Gray Cat Labs
<http://graycat.io>

Sheet: /
 File: working.kicad_sch

Title: UTCape

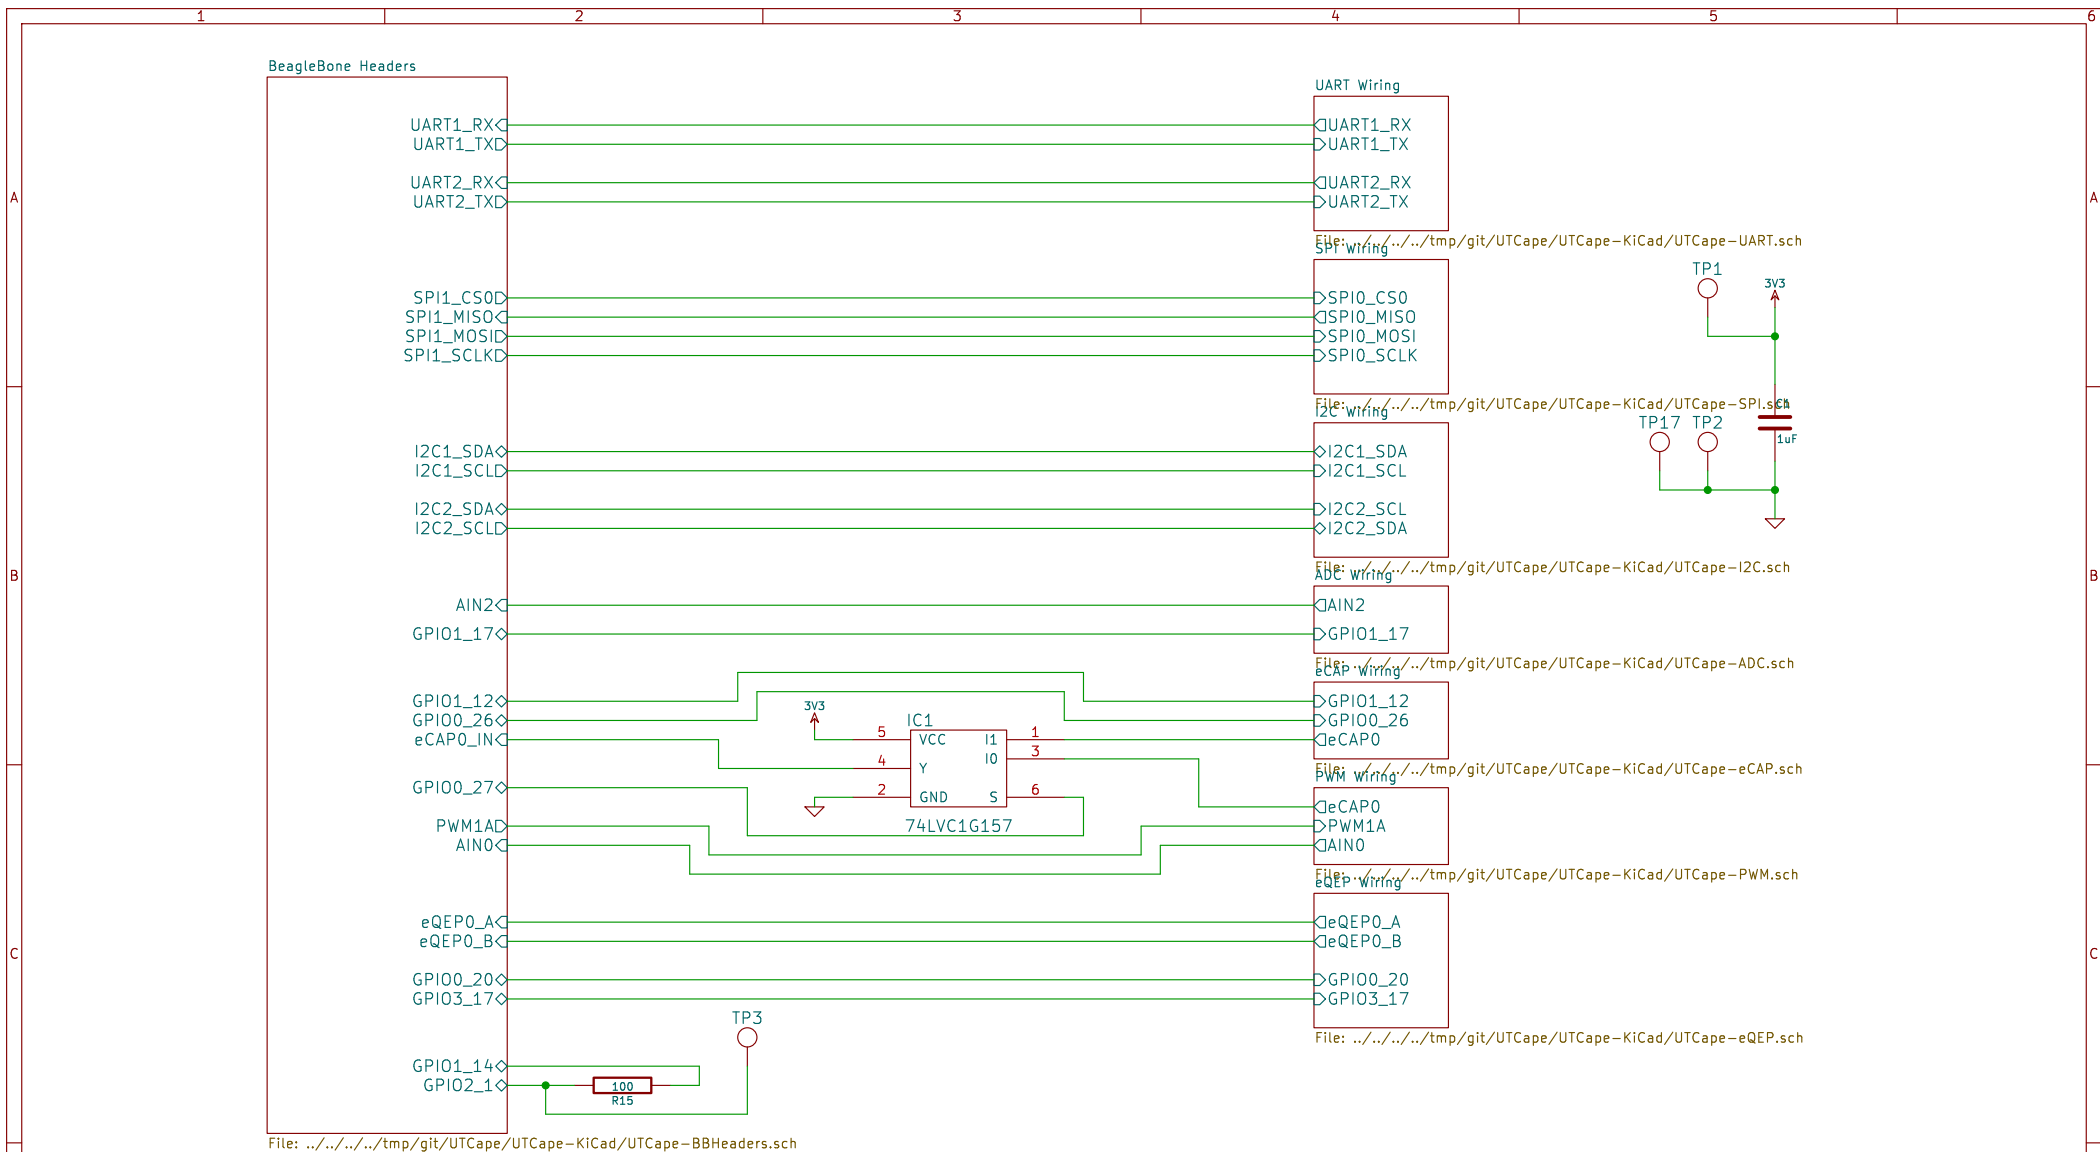
1. Is IC1 really needed, or am I just not seeing a second eCAP input?
